December 16, 2003 CPC

STAFF'S  
REQUEST ANALYSIS  
AND  
RECOMMENDATION

04PR0139

Duval Development  
(Oaklake Builder's Choice 2)

04PR0139  
OAK LAKE BUILDER'S  
CHOICE 2

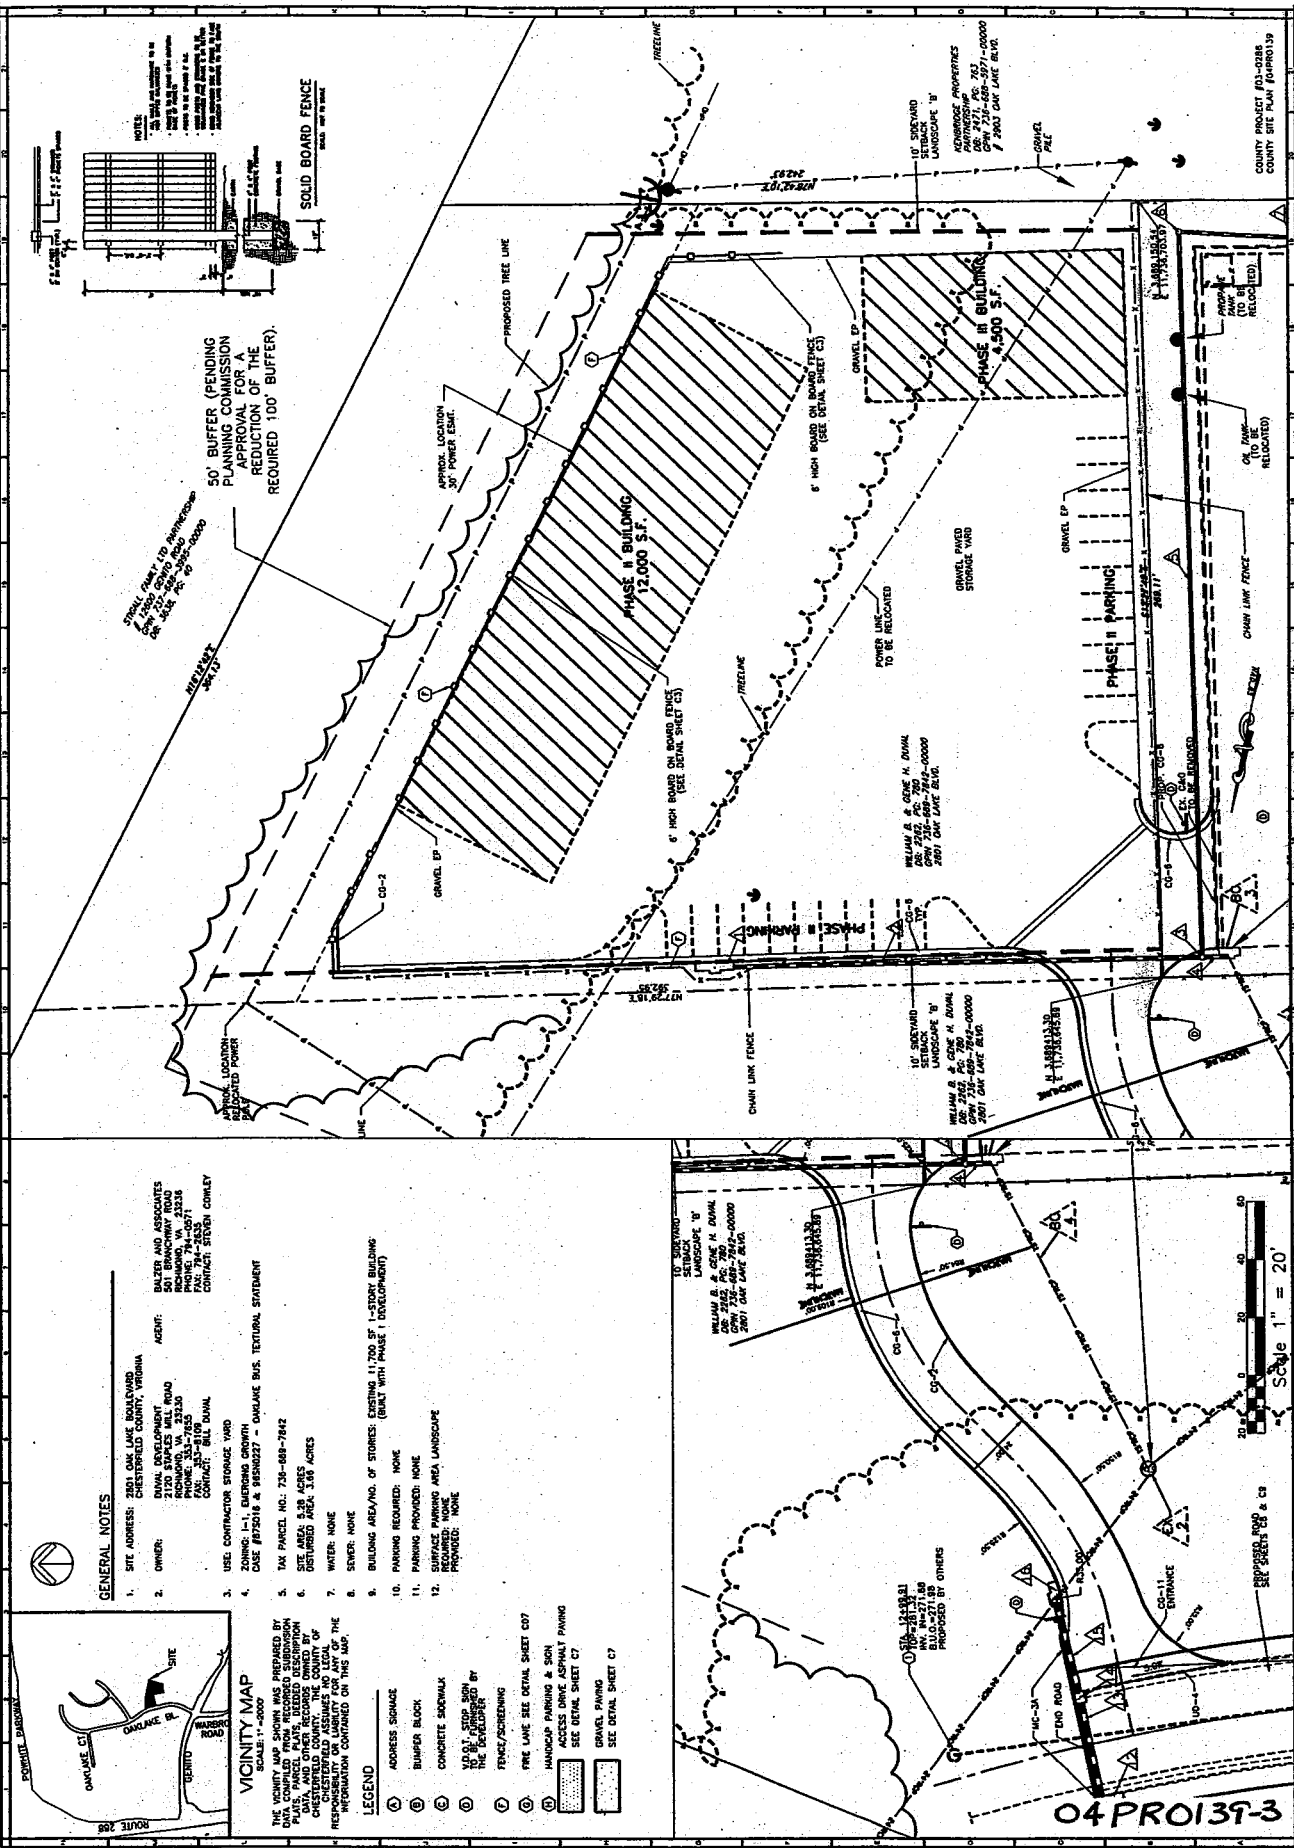
1. An adequate turnaround shall be provided at the terminus of Oaklake Crest Way to allow for the safe and convenient maneuvering by service vehicles. Provide a permanent cul-de-sac with a thirty-five (35) foot pavement radius (within a minimum fifty (50) foot radius temporary turnaround easement) using Virginia Department of Transportation (VDOT) standard curb and gutter as stipulated in 24 VAC 30-90-240 of the 1996 SSR. (VDOT)

2. VDOT standard CG-11 is the required standard for all curbed commercial entrances. The minimum commercial entrance width is thirty (30) feet at the right-of-way line. A radius of thirty-five (35) feet at the curb is required. This applies to Oaklake Crest Way as well. (VDOT)

3. The spot elevations along with flow line of CG-11 must be shown on the plans to ensure positive drainage. A typical section shall be added to the plan. It should indicate a straight positive flow line from gutter to gutter. This applies to Oaklake Crest Way as well. (VDOT)

6. The revised plan is for a builder's storage yard. No buildings are proposed at this time. If buildings are to be constructed or moved to the location, a re-review of the site plan will be required for evaluation of fire protection needs. The revised plan as submitted, for an open contractor's storage yard, only, is approved as submitted. (F)

7. Provide calculations to verify that the fire flow and domestic flows can be sustained with a residual pressure of 20 PSI. Show on the plans the County-supplied starting point letter, flow chart and engineer's results in the form of a node map and table of flows and resultant pressures. (U)

8. Take the water connection from the twelve (12) inch waterline in Oaklake Boulevard. Show an eight (8) inch waterline in Oaklake Crest Way. (U)
9. Show open cut for crossing Oaklake Boulevard if the twelve (12) inch waterline is within the pavement. (U)

10. More information is needed on the proposed services. Submit sizing forms. (U)
11. Shift manhole #1 east along the sewer line until the angle with the downstream sewer at the existing manhole is ninety (90) degrees or greater. (U)

13. All existing and proposed drainage easements must be shown. (EE)
14. The deed book and page number of all existing drainage easements must be shown on the plan. (EE)

15. Provide a "drainage easement - public" over Structure 15. (EE)
16. Provide a construction entrance for Oaklake Crest Way. (EE)
17. All on-site drainage easements including right of way must be recorded prior to issuance of a land disturbance permit for this project. (EE)

- d) A performance bond must be posted for the construction of Oaklake Crest Way. (EE)
20. Revise and resubmit the site plan incorporating the proposed phased buildings on the site for review by all county departments. (P)

21. Provide a note on the site plan stating: "fifty (50) foot buffer and tree save area - no access permitted. Existing trees within the buffer may be credited toward buffer vegetation requirements (1.5 x perimeter landscape C). Upon completion of site grading, the owner or his representative shall contact Jeff Lamson (748-4158) of the Planning Department to inspect existing plant material to determine if additional plant material must be installed to meet requirements." (P)

1. The buffer may be reduced to a fifty (50) foot buffer along the east and north boundary of this site plan. Existing vegetation within this buffer shall be retained. Landscaping within this buffer shall comply with Section 19-522(a)(2) Buffer and screening requirements for fifty (50) foot buffers. If existing vegetation does not satisfy this requirement, as determined in the field by the Planning Department, a landscape plan shall be submitted to the Planning Department for review and approval prior to occupancy of the building.

2. Construction of the Phase 2 building and a six (6) foot tall screen fence made of the same material as the building shall be complete within three (3) years of the issue date of the land disturbance permit for this site plan. The screen fence shall be located adjacent to and in line with the rear wall of the building, and shall provide screening in areas where no building is located parallel to the eastern property line.
